Addendum No. 1

Contract No.: DA00169

WBS No.: 42999.3.1

*Drainage, Grading and Paving to improve curve radius on SR 1227 (South Mills Rd.),
Currituck County*

26-SEP-2013 14:47
 User: S:\Users\g...
 Path: D:\Current Projects\South Mills Rd\42999.31\DDC-sh4.dgn
 File: D:\Current Projects\South Mills Rd\42999.31\DDC-sh4.dgn

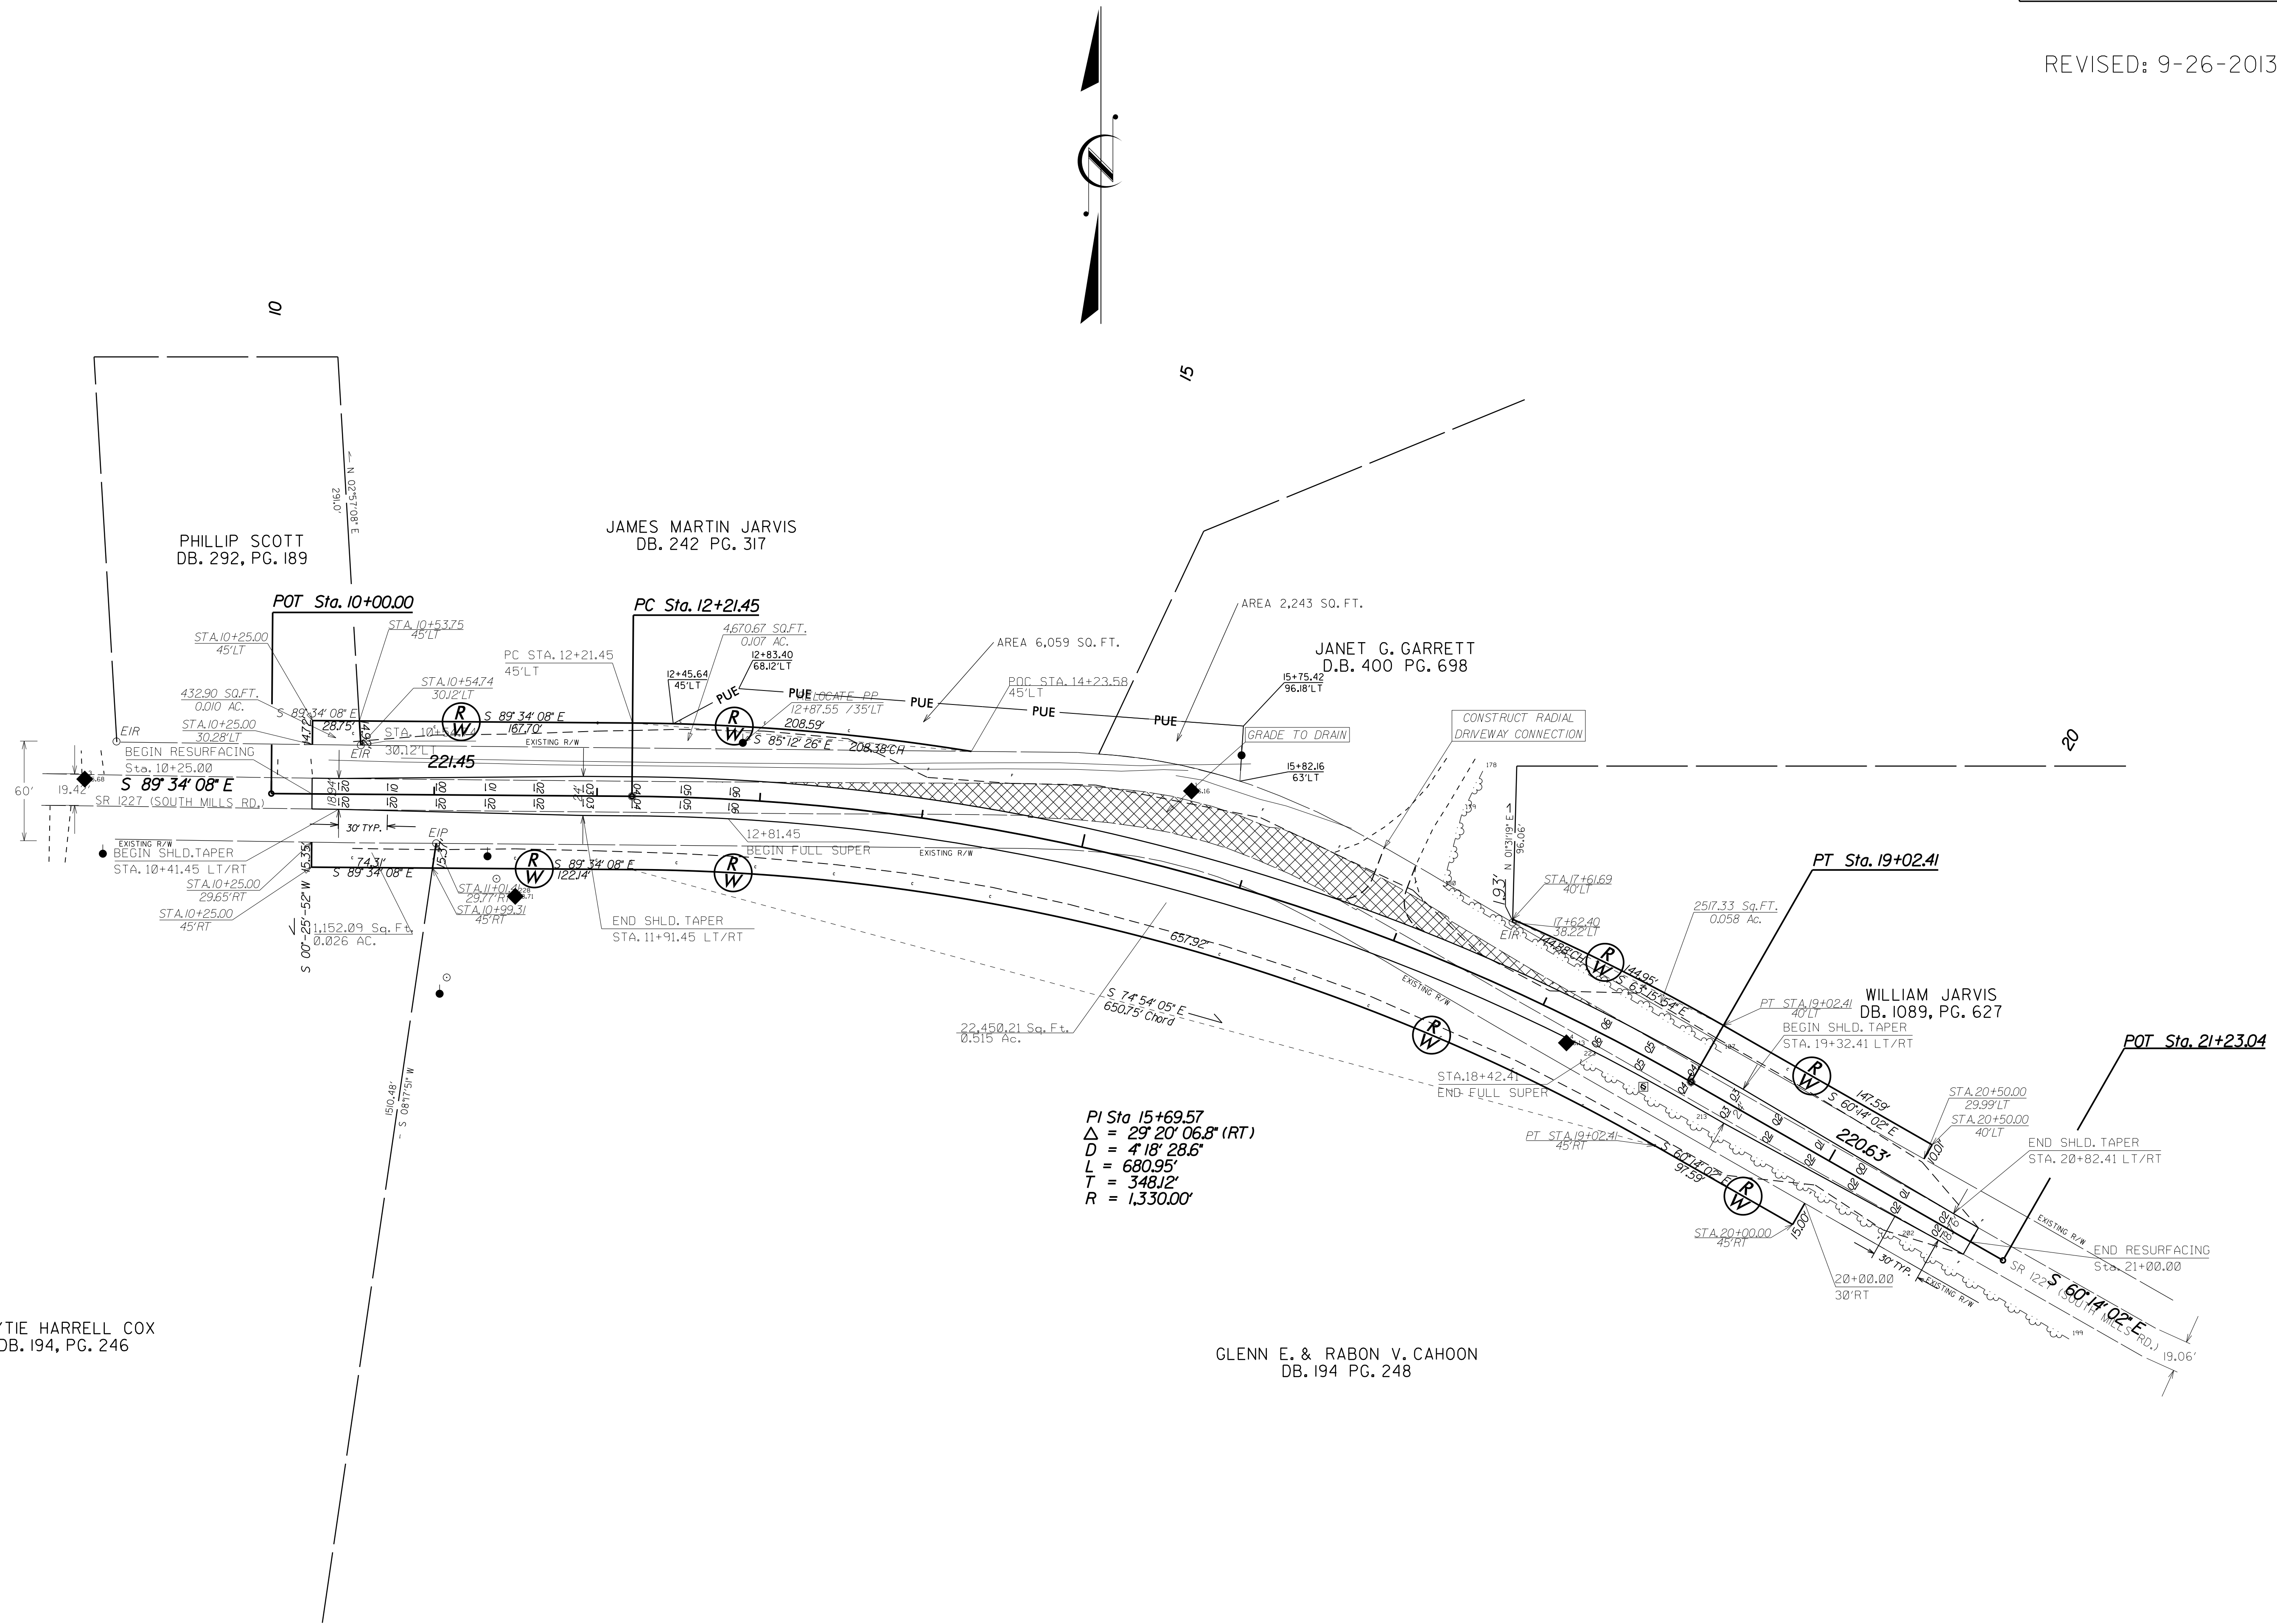
Plan Sheet 4, has been revised to illustrate the updated pavement removal areas. Please void the existing Plan Sheet 4 in the proposal and staple revised Plan Sheet 4 thereto and acknowledge addendum on the Bid Form.

CENTERLINE PROFILE
 REVISED: 9-26-2013

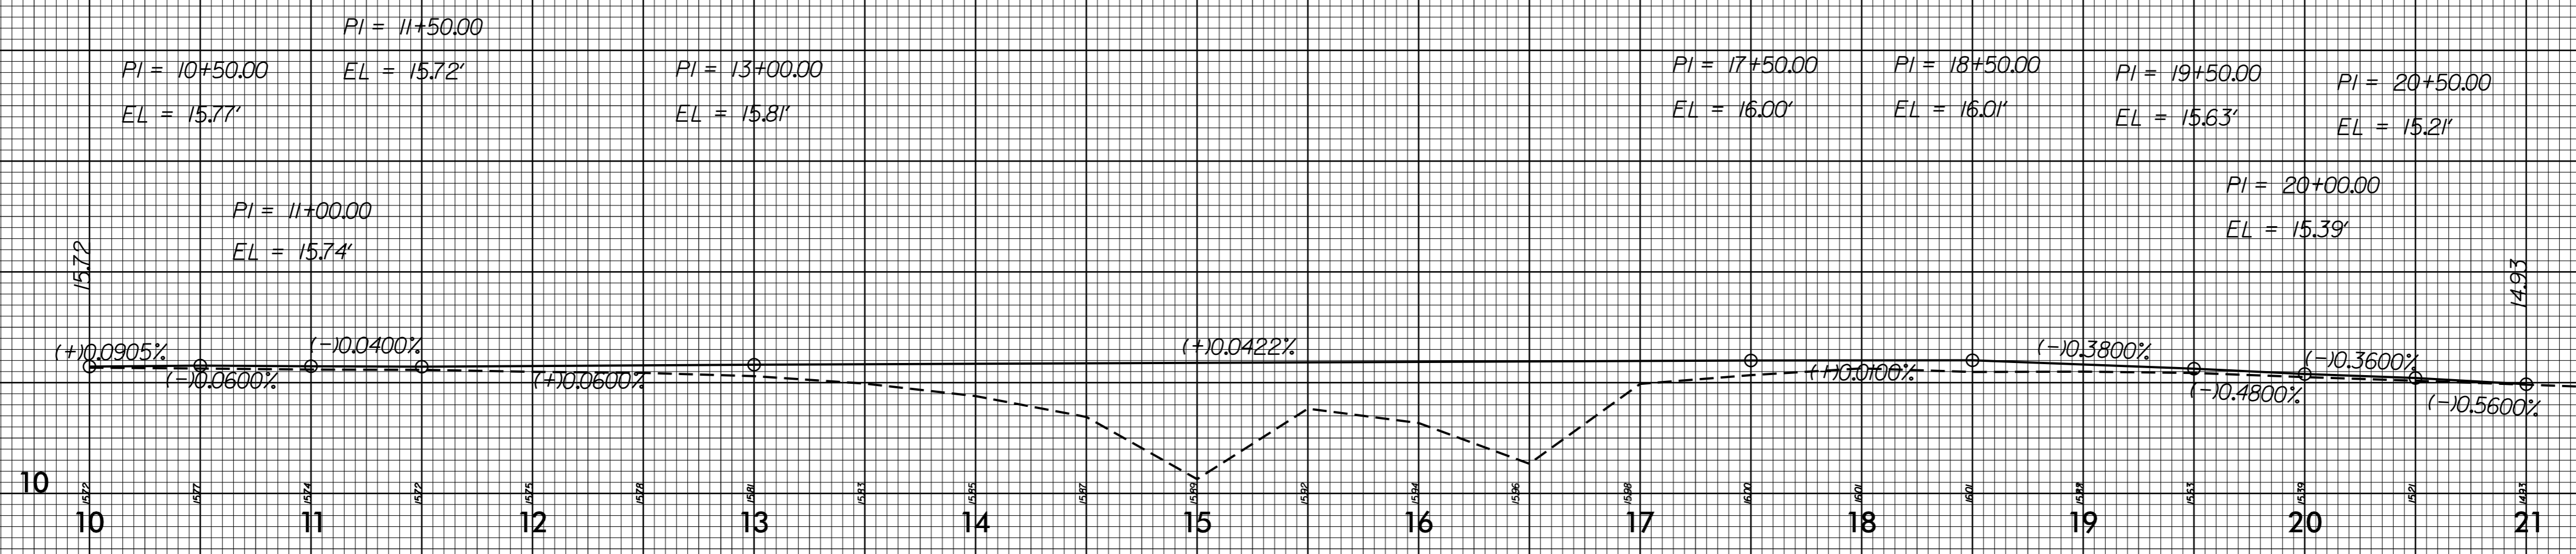
Plan Sheet 5, has been revised to illustrate the updated centerline profile. Please void the existing Plan Sheet 5 in the proposal and staple revised Plan Sheet 5 thereto and acknowledge addendum on the Bid Form.
